Change of Color Bins for Cree® P2 & P4 White LEDs

PCN-CM049

Announcement Date: June 13, 2014

IMPACT OF CHANGE

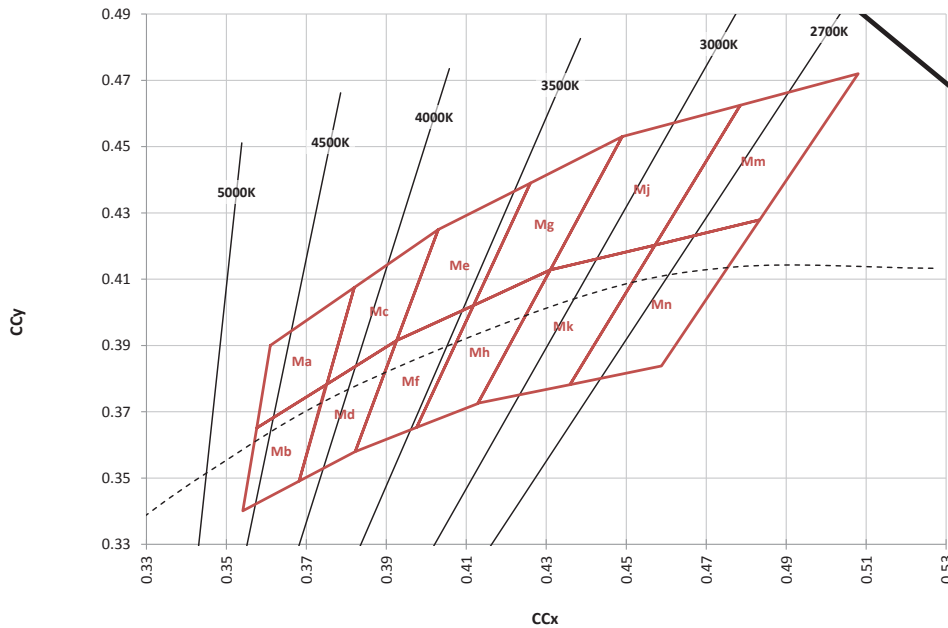
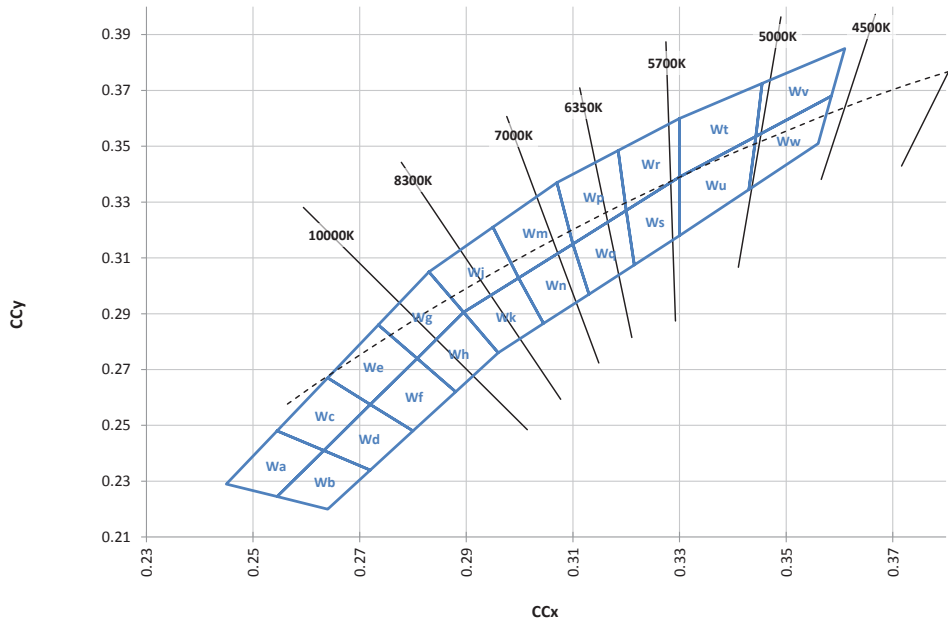
Effective immediately, Cree will ship all P2 and P4 white LEDs sorted to the new 1/16 color bin format shown on the following pages.

CIE Chromaticity Diagrams for Old 1/4 Bin Format

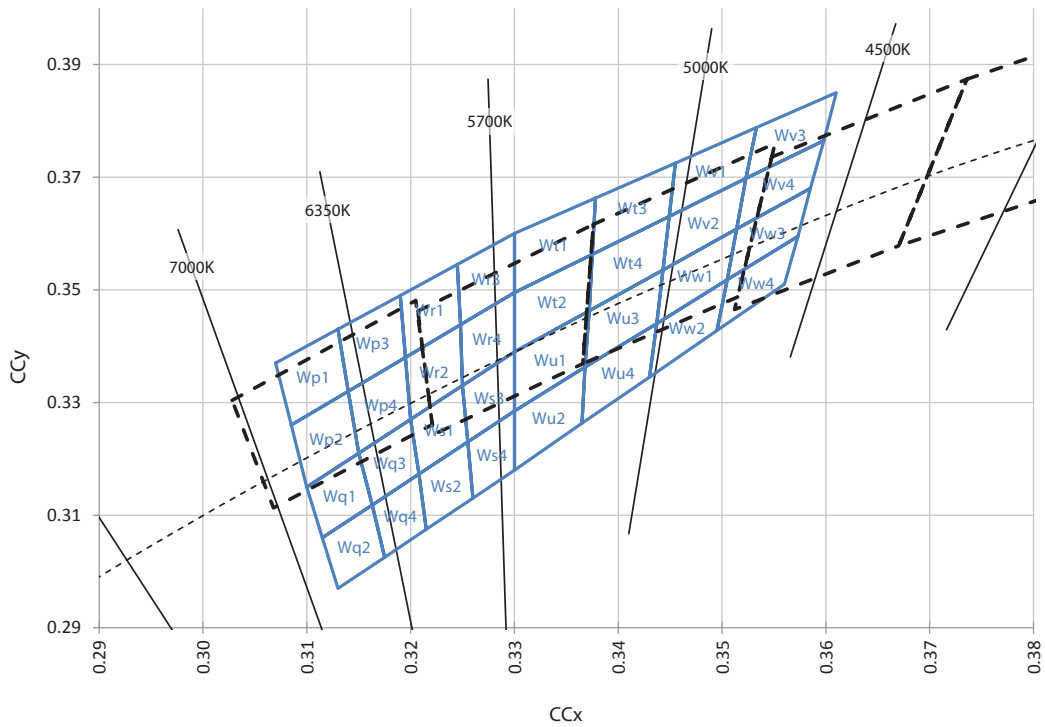
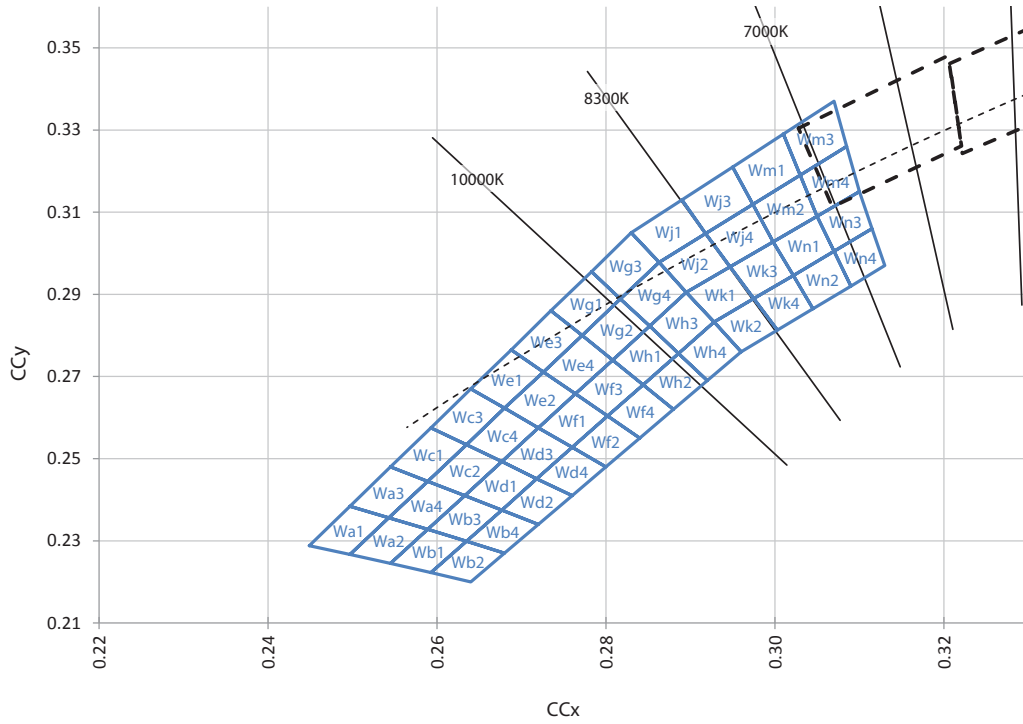
Cree will begin shipment of all P2 and P4 white LEDs in the new 1/16 bin format described below. No kit codes change in the new color bin format. Please refer to the product data sheets for the new bin coordinates.
